Access Compliance Report

Public Rights-of-Way

(Curb Ramps)

Intersection ID: 47113	Main Street: ELIZABETH_OAKS_AV	Cross Street: TINDLE_HILL_LN	Location: W
ADA ID: 3CF44F3E4D04	Ramp Type: PerpDiag	Initial Pass/Fail: Fail	Overall Compliance: No
Severity Score: 8.75			
Codes/Mitigation Info/Possible Solution		Field Measurements/Component Compliance

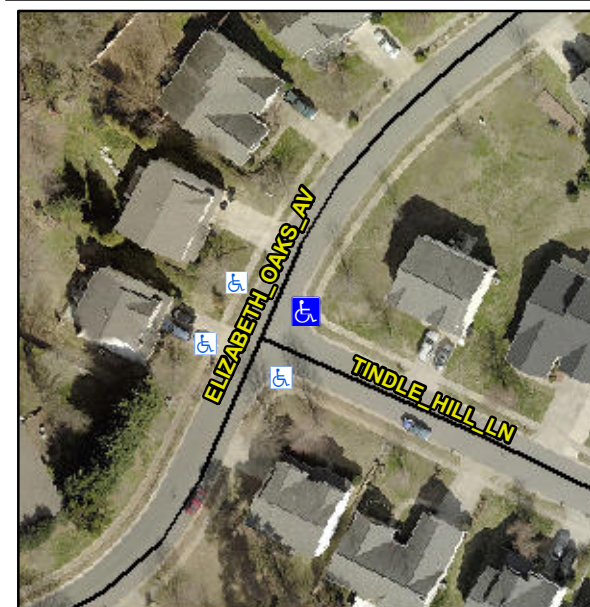
Not Found, R304.5.1

Compliance	Description	Data	Compliance	Description	Data
N/A	Ramp Length (in)	46.0	Yes	Ramp Slope (%)	5.1
No	Ramp Width (in)	47.0	Yes	Ramp XSlope (%)	1.4
N/A	Flare Type LT	N/A	N/A	Flare Type RT	N/A
N/A	Flare Slope LT (%)	N/A	N/A	Flare Slope RT (%)	N/A
N/A	Flare Traversable LT?	N/A	N/A	Flare Traversable RT?	N/A
N/A	Landing Length (in)	N/A	N/A	DWS Provided?	N/A
N/A	Landing Width (in)	N/A	N/A	DWS Contrast?	N/A
N/A	Landing Slope (%)	N/A	N/A	DWS Length (in)	N/A
N/A	Landing X Slope (%)	N/A	N/A	DWS Full Width?	N/A
N/A	Landing Curb? (Y/N)	N/A	N/A	DWS Offset (in)	N/A
N/A	Shared Landing?	N/A			
N/A	Gutter Ponding?	N/A	N/A	Gutter Slope (%)	N/A
N/A	Gutter Lip Ht (in)	N/A	N/A	Gutter X Slope (%)	N/A
N/A	Painted X Walk1?	No	N/A	Painted X Walk2?	No
	X Walk 1 Direction	To NE		X Walk 2 Direction	To SE
N/A	X Walk 1 Width (in)	N/A	N/A	X Walk 2 Width (in)	N/A
	X Walk 1 Slope (%)	4.3		X Walk 2 Slope (%)	7.0
	X Walk 1 X Slope (%)	4.4		X Walk 2 X Slope (%)	4.5

N/A	Ramp inside XWalk1?	N/A	N/A	Ramp inside XWalk2?	N/A
	Road Slope (%)	0.4	N/A	Clear Space?	N/A
	Road X Slope (%)	6.7	N/A	Clear Space to XWalk (in)	N/A
N/A	Any Obstructions?	N/A	N/A	Storm Grate/Utility Hazard?	N/A
	Obstruction Type			Storm Grate/Utility Type	
		N/A			N/A
			Yes	Surface Condition? (G/P)	Good

Remove & Replace Curb Ramp With Two New Directional Ramps or Equivalent.
